SECTION 009113 – ADDENDUM TWO

- A. Project Name: 22034.02 Meridian High School
- B. Owner: Meridian Public School District, 1019 25th Avenue, Meridian, MS 38391
- C. Architect: Dale | Bailey, an Association, One Jackson Place, Suite 250, 188 East Capitol Street, Jackson, MS 39201-2100
- D. Architect Project Number: 22034.02
- E. Date of Addendum Two: 7 September 2023

S-602

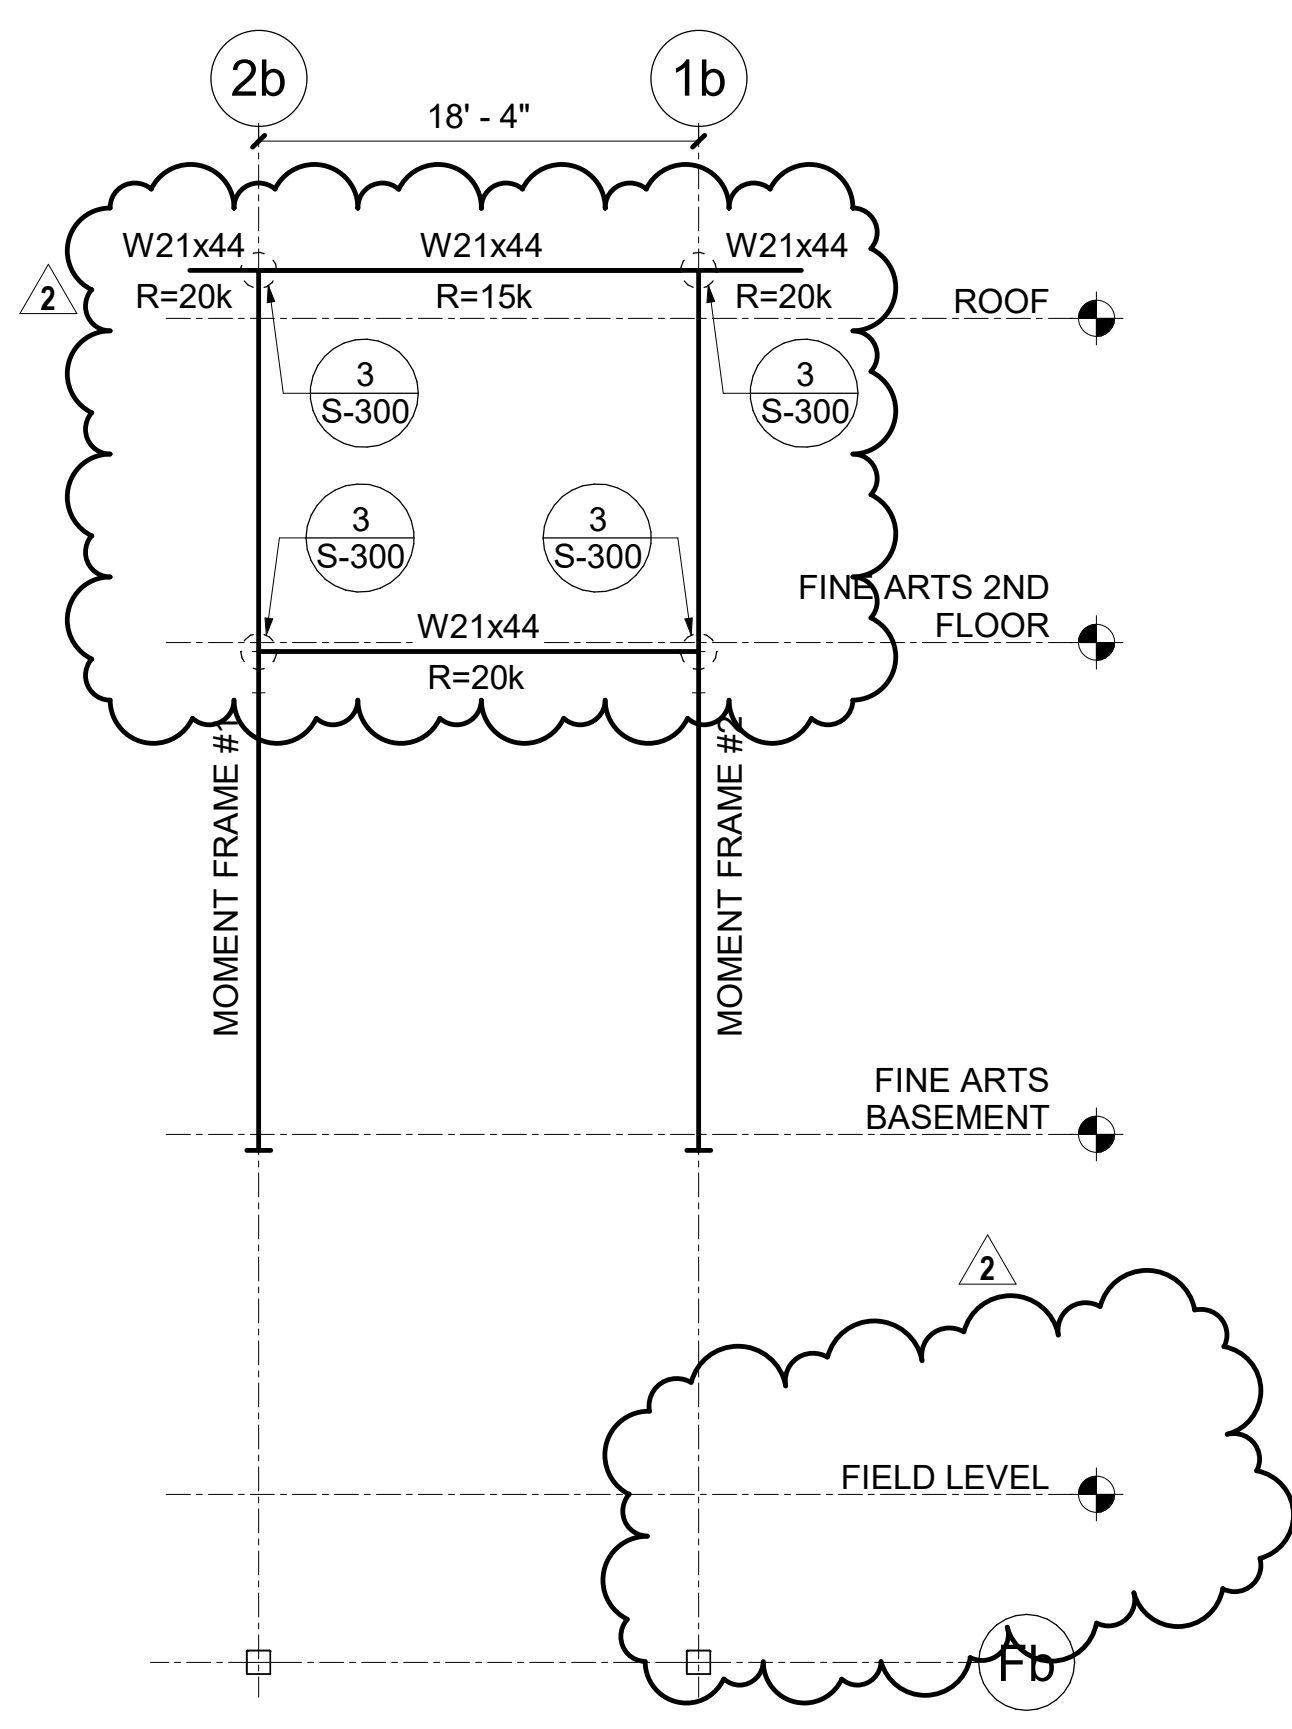
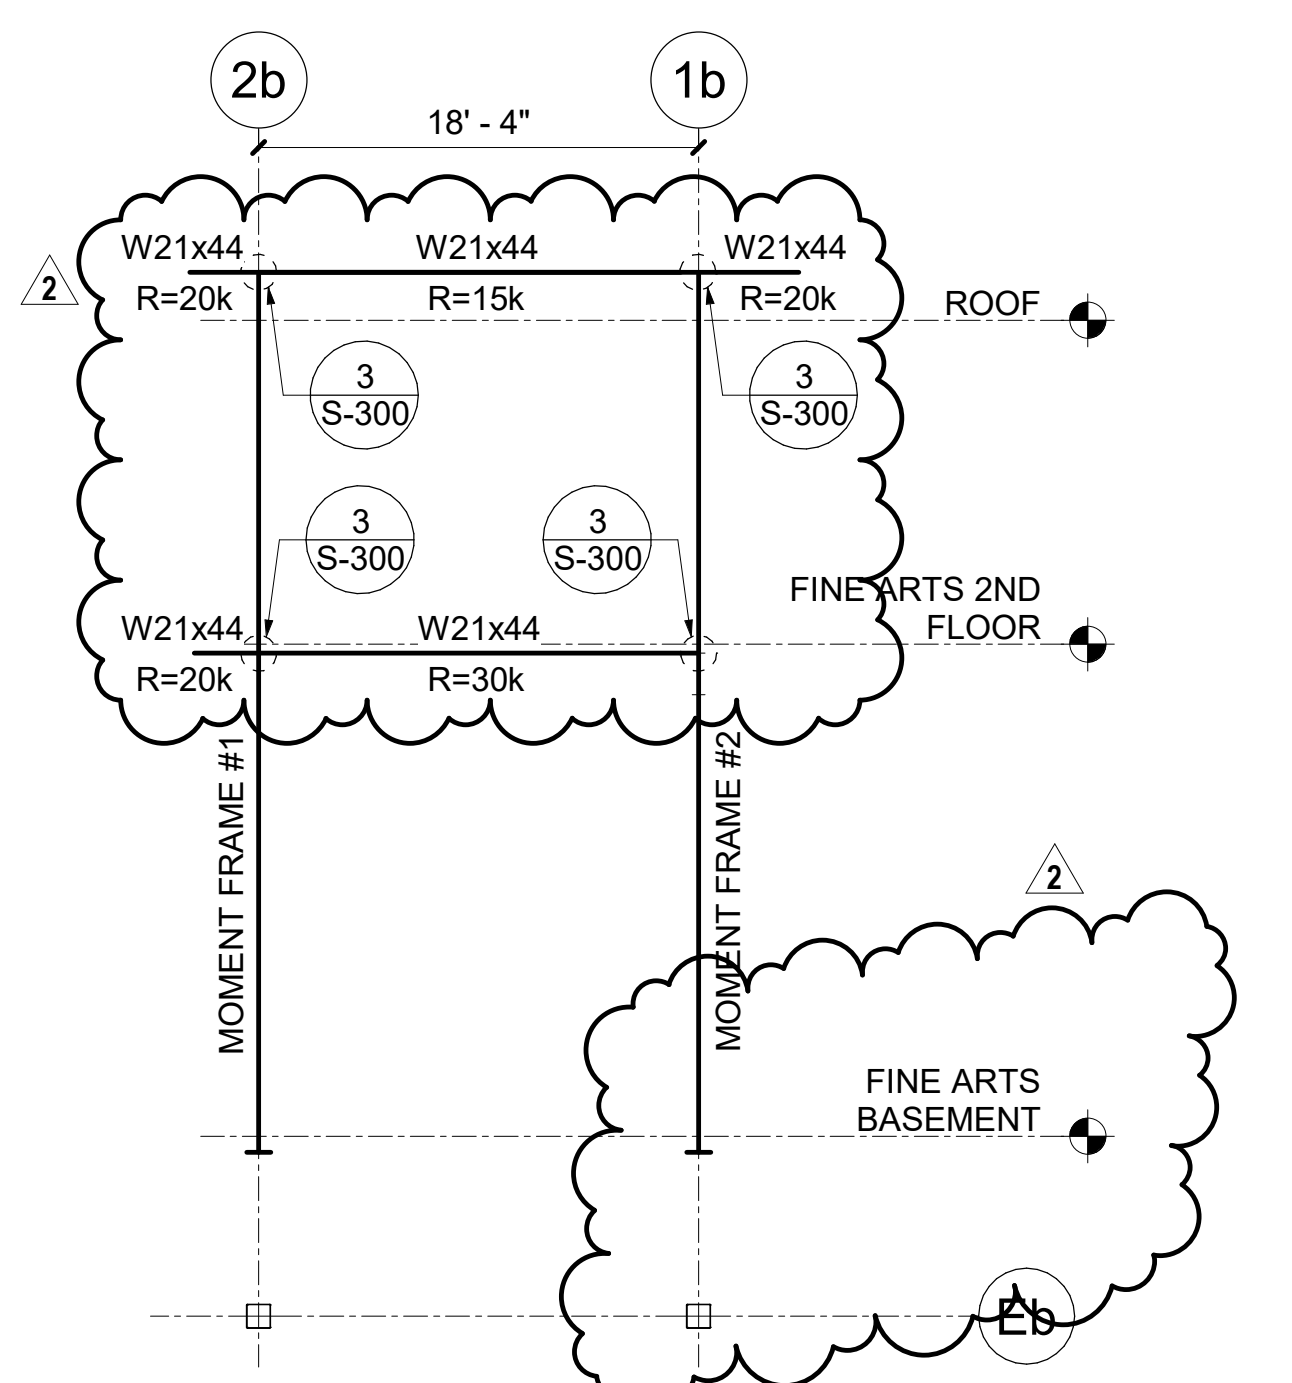
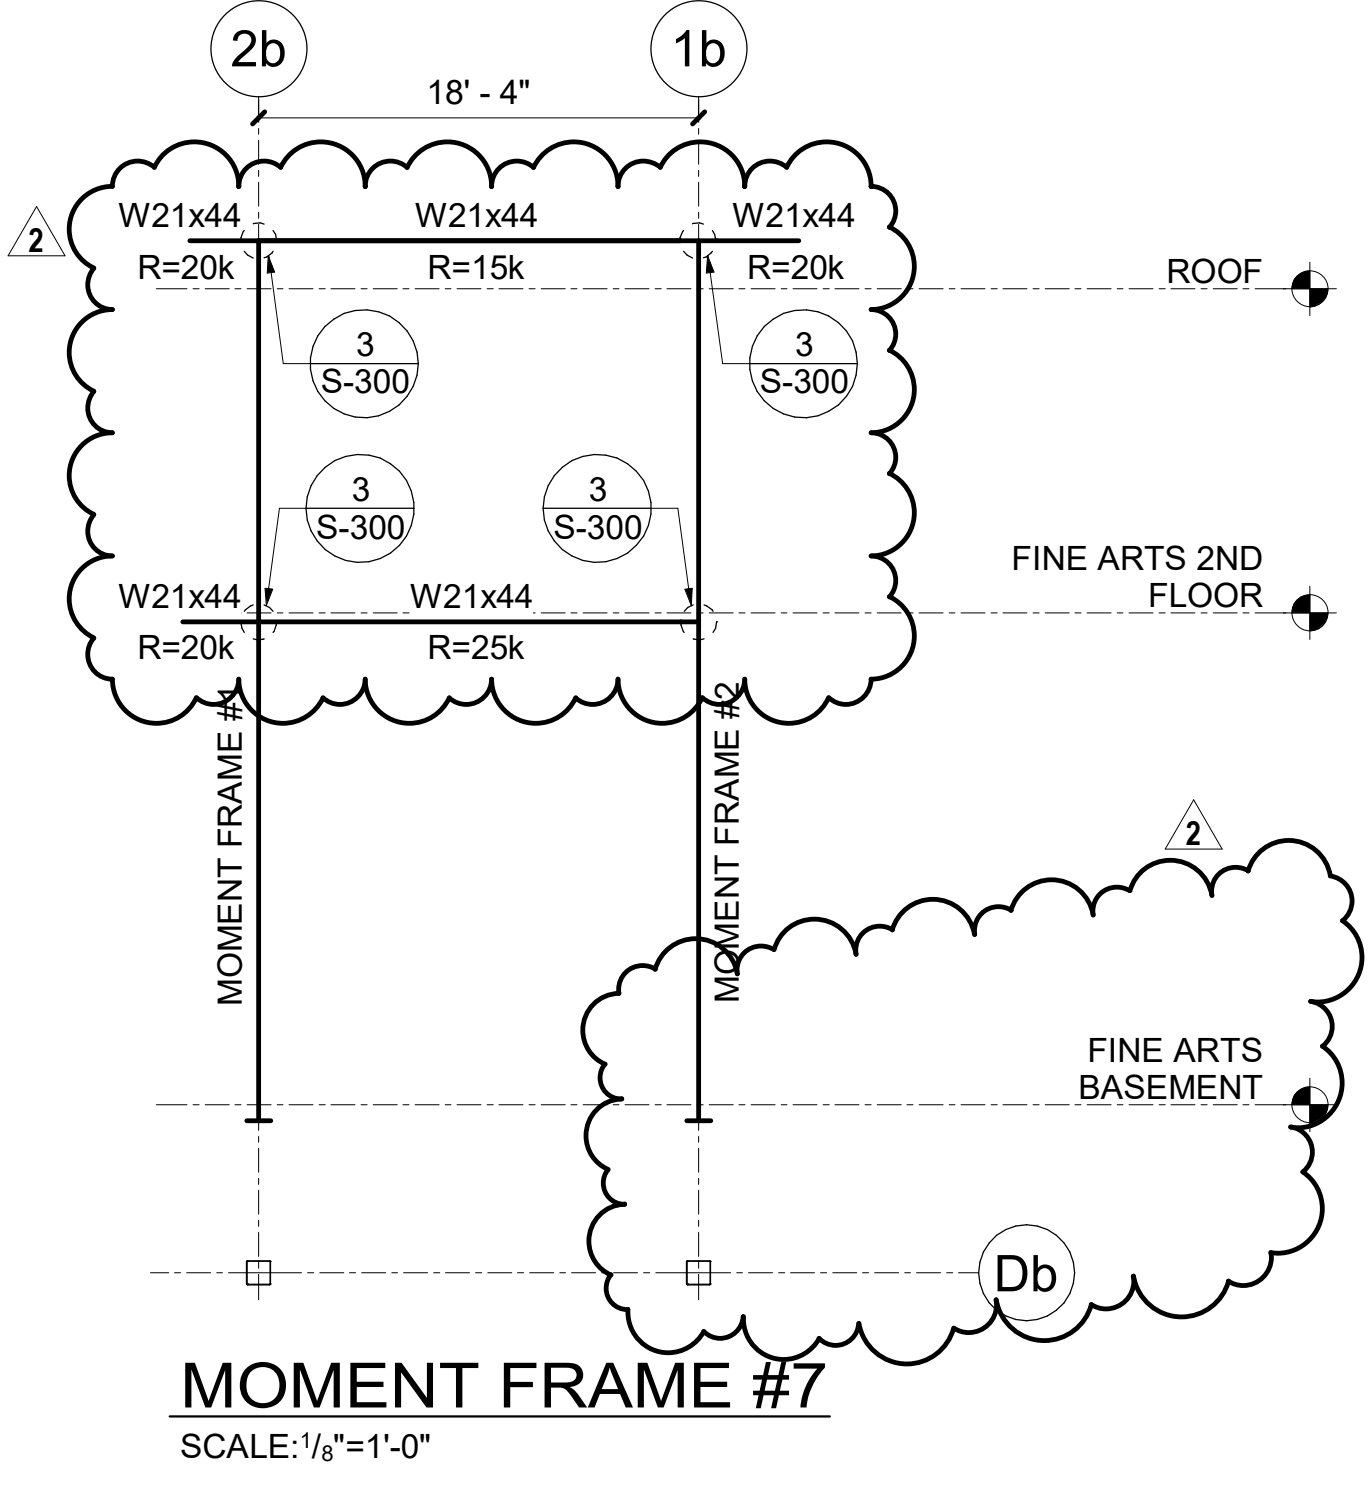
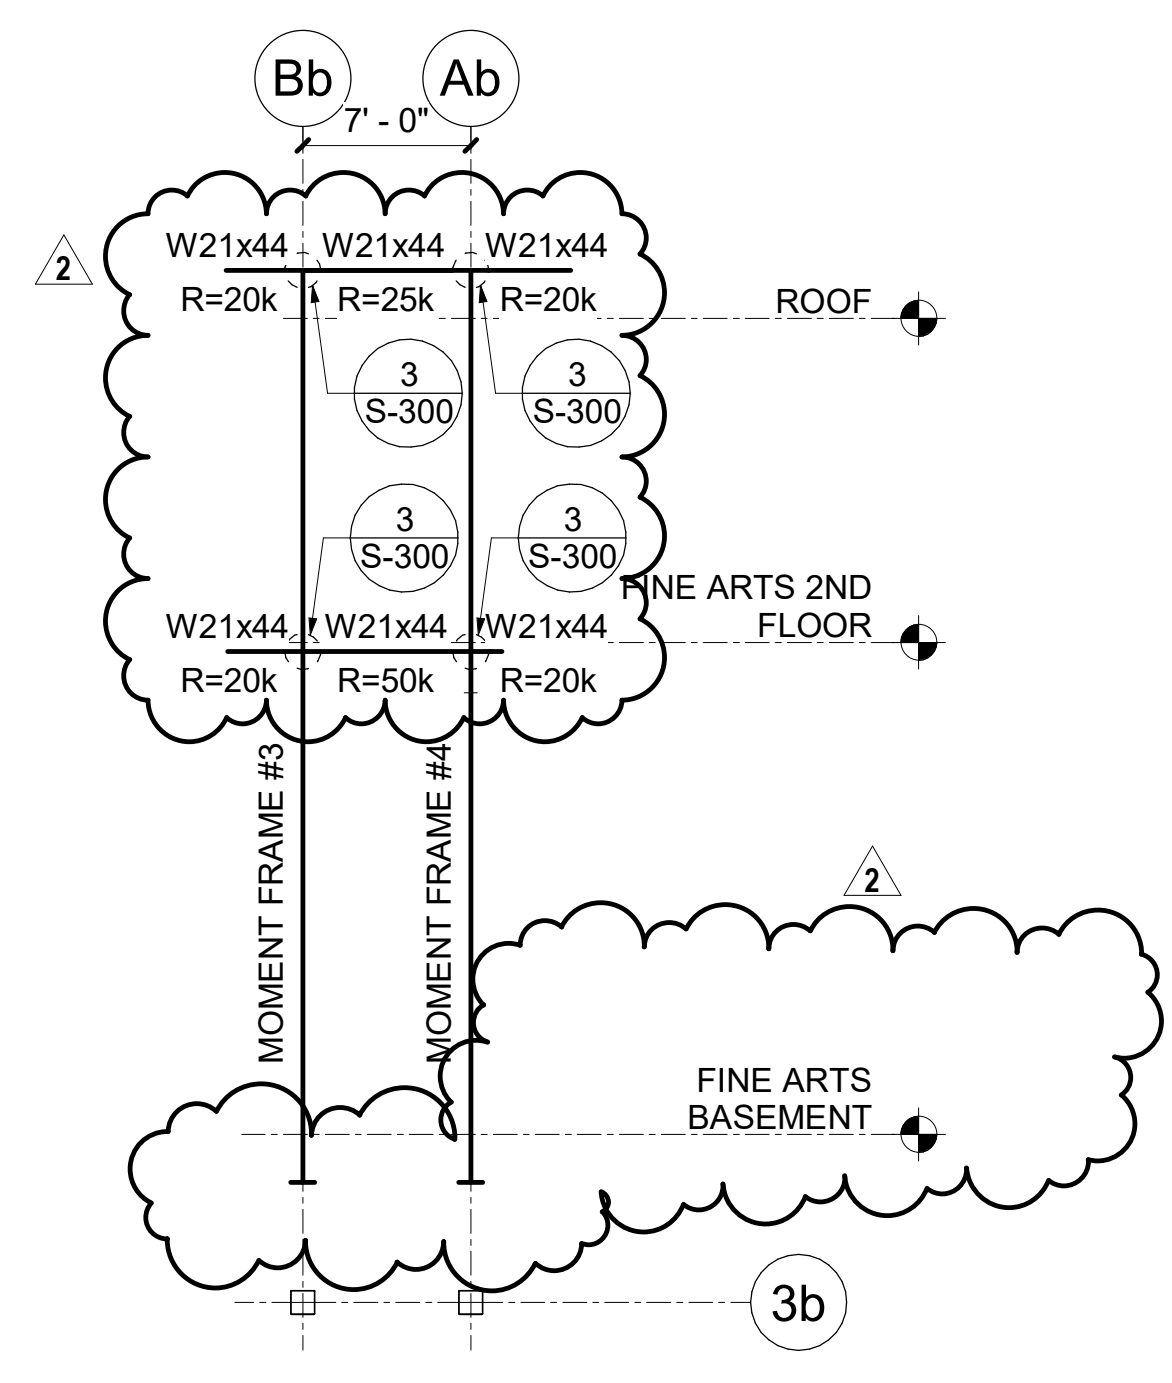
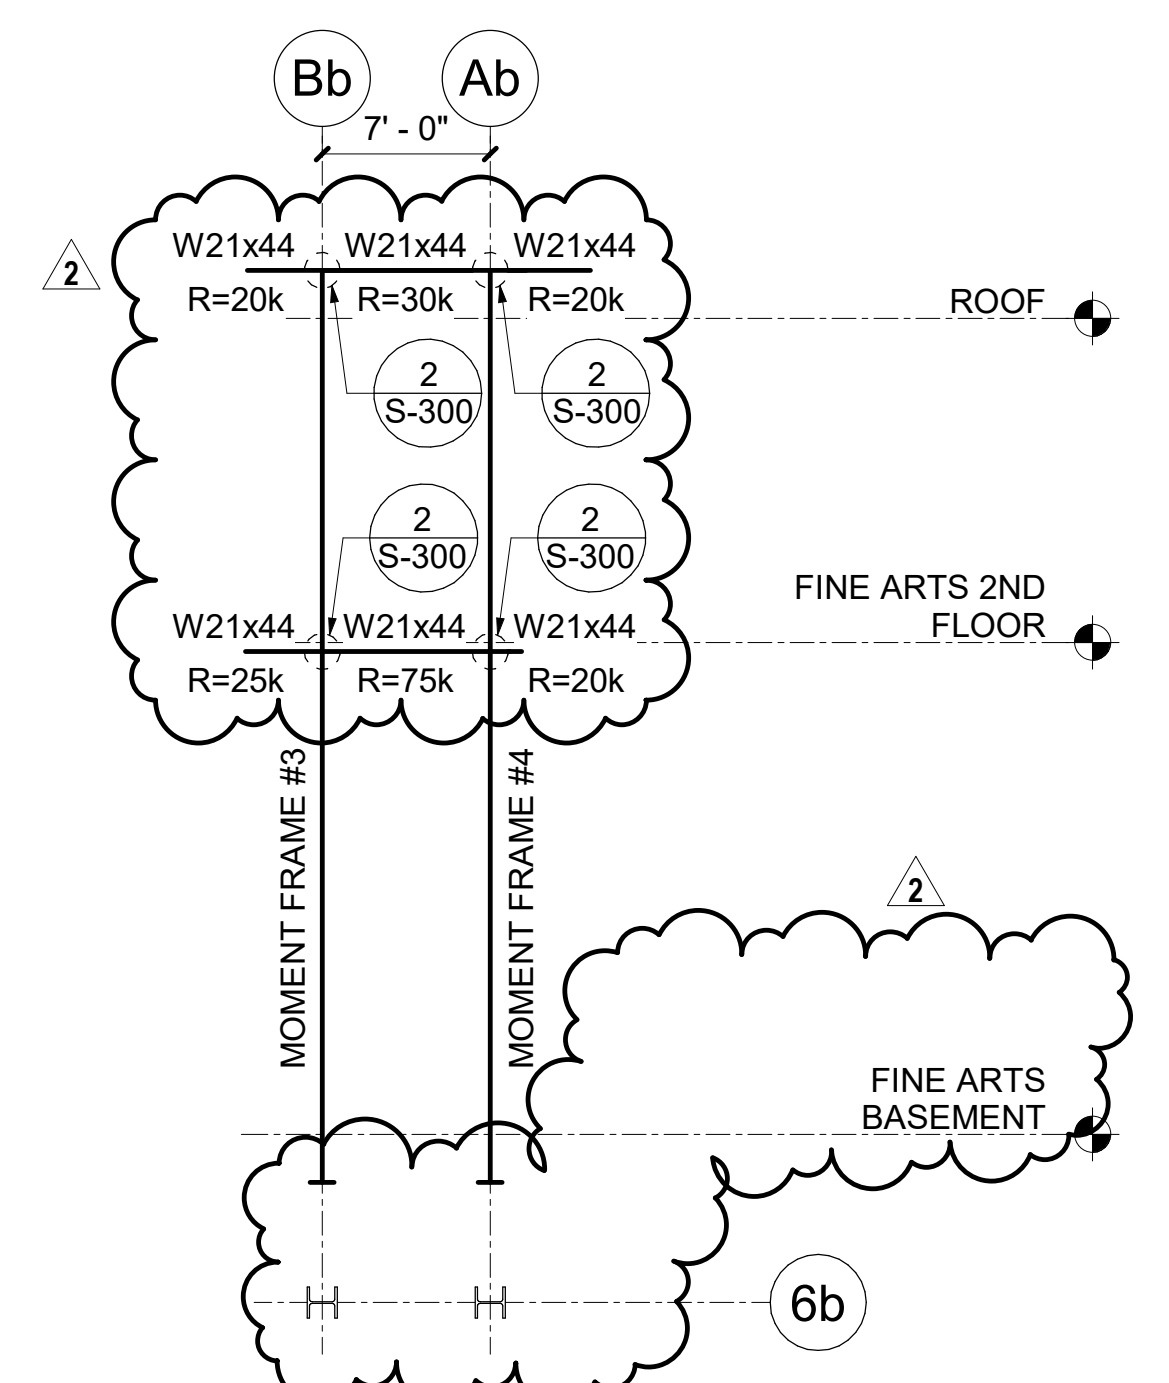
- D. Sheet S-602 – Moment Frame Elevations. (Revised). Delete this sheet in its entirety and replace it with attached. Indicated Moment connection details on moment frame elevations. Added cantilever beam sizes and reactions.
